# Padma Satel Arab Fashions Ltd. P & K Fashion Ltd. Luna Fashion Ltd.

Luna Complex, Joybangla road, Borobari, Gazipur, Dhaka

# Observations

# Localized areas of high loading

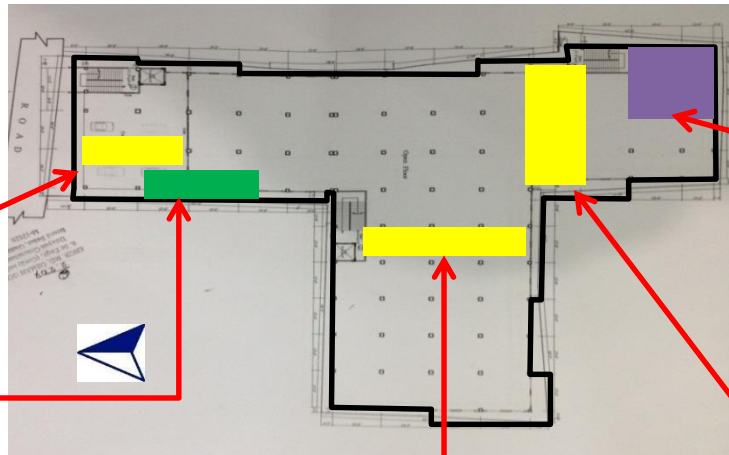
Areas of high loading on structure including cantilevers. No load management plan available for the building.

Item No.	Observation	Recommended Action Plan	Recommended Timeline
8	No floor load management plan	Produce and actively manage a loading plan for all floor plates within the factory giving consideration to floor capacity and column capacity (refer to Item 1).	6-weeks
9	No floor load management plan	Continue to implement load management plan.	6-months
10	Apparently non-engineered steel fire escape stairs on southern elevation of the EW building	Building engineer to review capacity of steel stair giving consideration to overall stability, section sizes used, stair bearing details and quality of fabrication	6-weeks
11	Apparently non-engineered steel fire escape stairs on southern elevation of the EW building	Building engineer to propose an necessary alterations/strengthening works	6-weeks
12	Apparently non-engineered steel fire escape stairs on southern elevation of the EW building	Ensure any necessary remedial works as advised by the Building Engineer are undertaken.	6-months

# Apparently non-engineered steel fire escape stairs

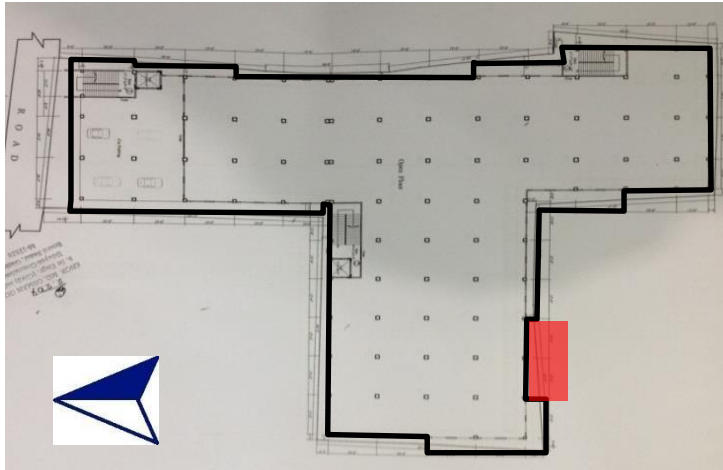
The steel fire escape stairs appears to be non-engineered. The main issues observed are:

- Overall stability under vertical and horizontal loads does not appear to have been achieved
- Bearing of stair to concrete landing appears inadequate
- Section sizes appear to be slender
- Corrosion of the structure has lead to holes in the tube sections

# Inconsistencies between structural drawings and as built construction

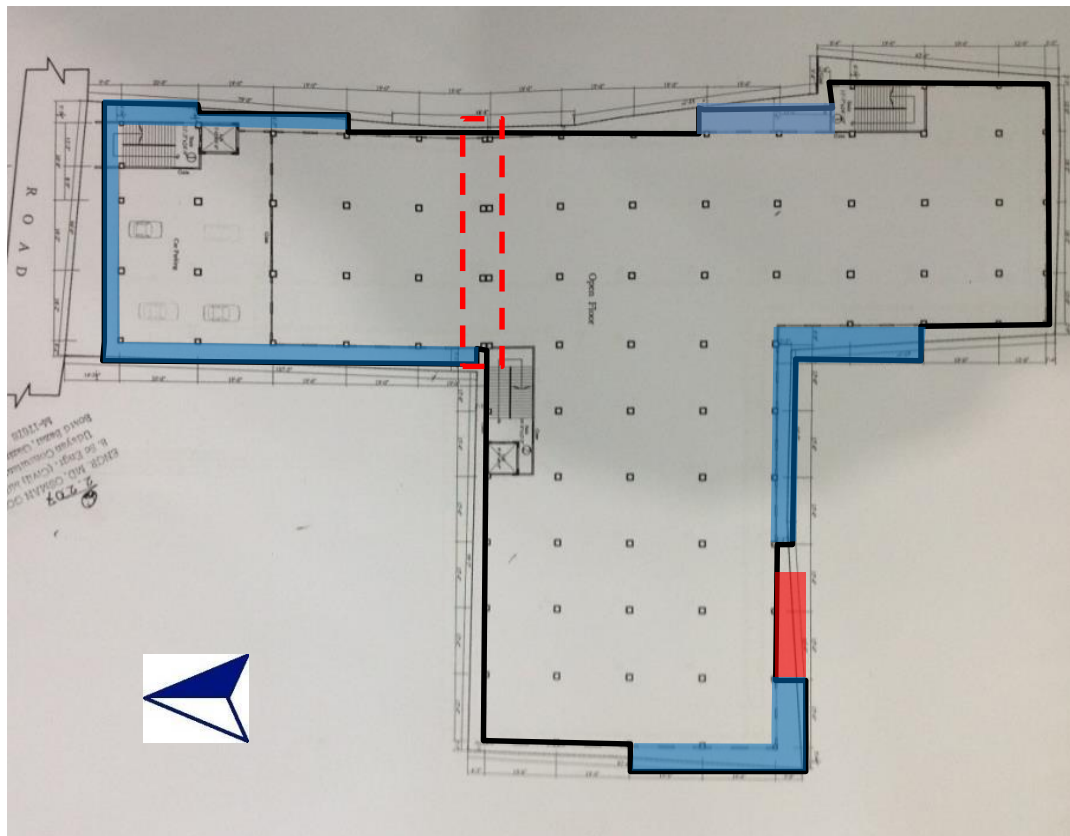
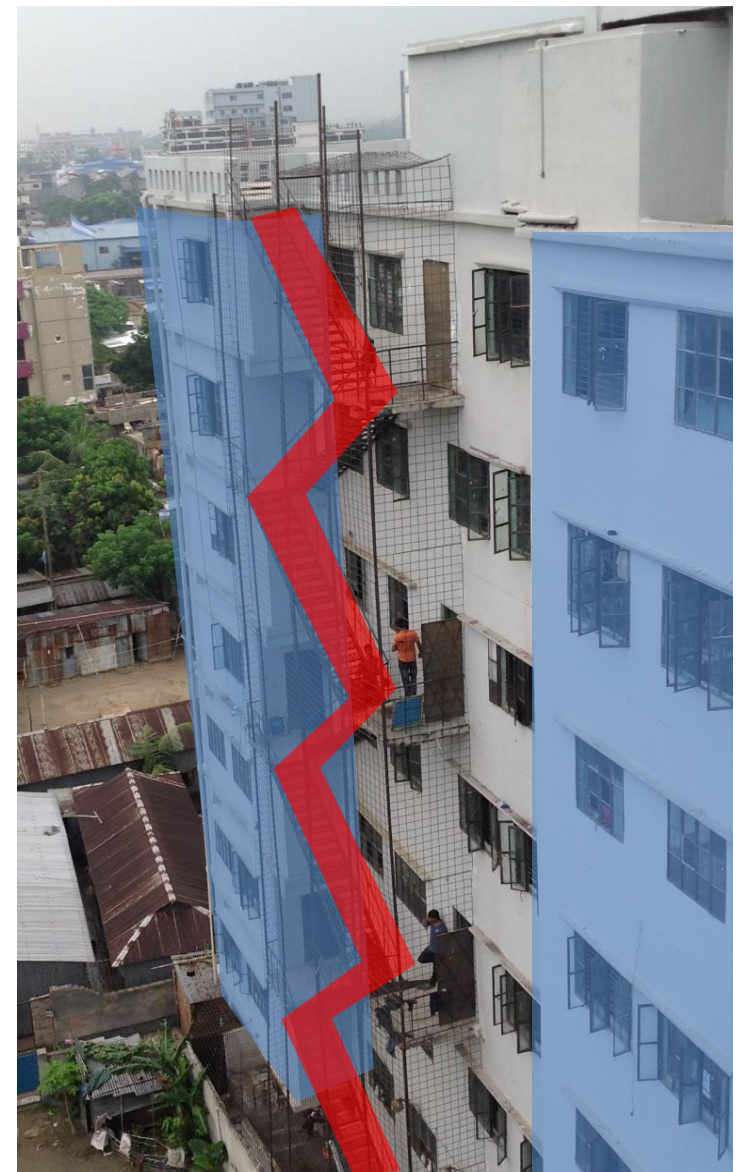
- Double columns shown on drawings, single column built
- Cantilevers not on structural drawings
- Undocumented steel escape stairs
- Observed floor plate layout

13	Inconsistencies between structural drawings and as built construction	Building engineer to survey building and prepare As-Built drawings as part of the Detail Engineering Assessment (refer to Item 1).	6-weeks
14	Inconsistencies between structural drawings and as built construction	Building engineer to identify “as built” cantilever slab and supporting column reinforcement and confirm adequacy of the structural sections.	6-weeks
15	Column protection at ground floor delivery area	Building engineer to review capacity of column protection to vehicular impact and propose strengthening works if required	6-weeks

# Column protection at ground floor delivery area

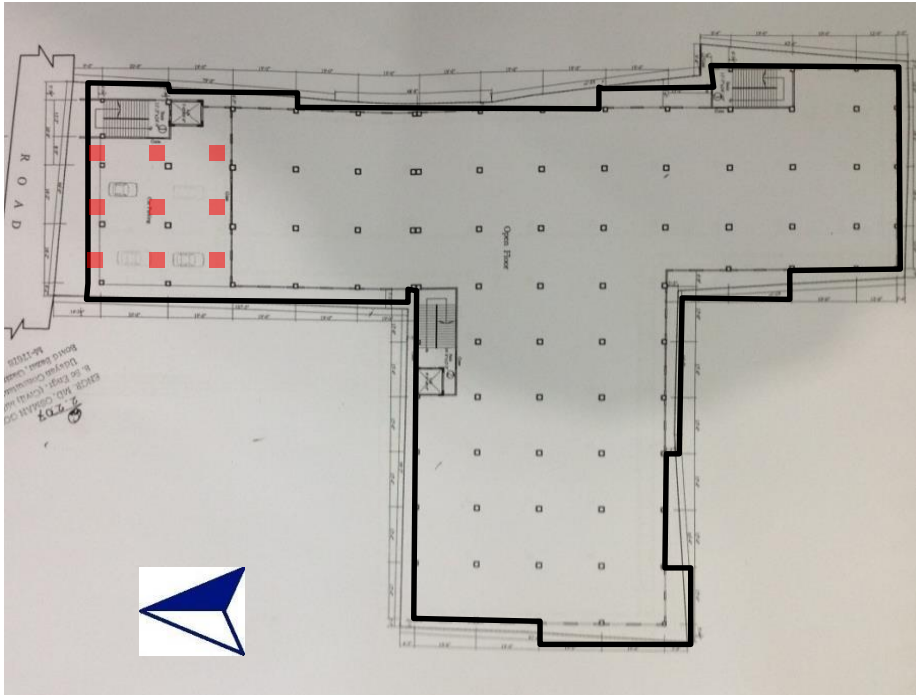
The ground floor columns in the parking/delivery area were partially surrounded by a metal angle frame. These frames appeared light and may provide little protection to the column if struck by a vehicle.
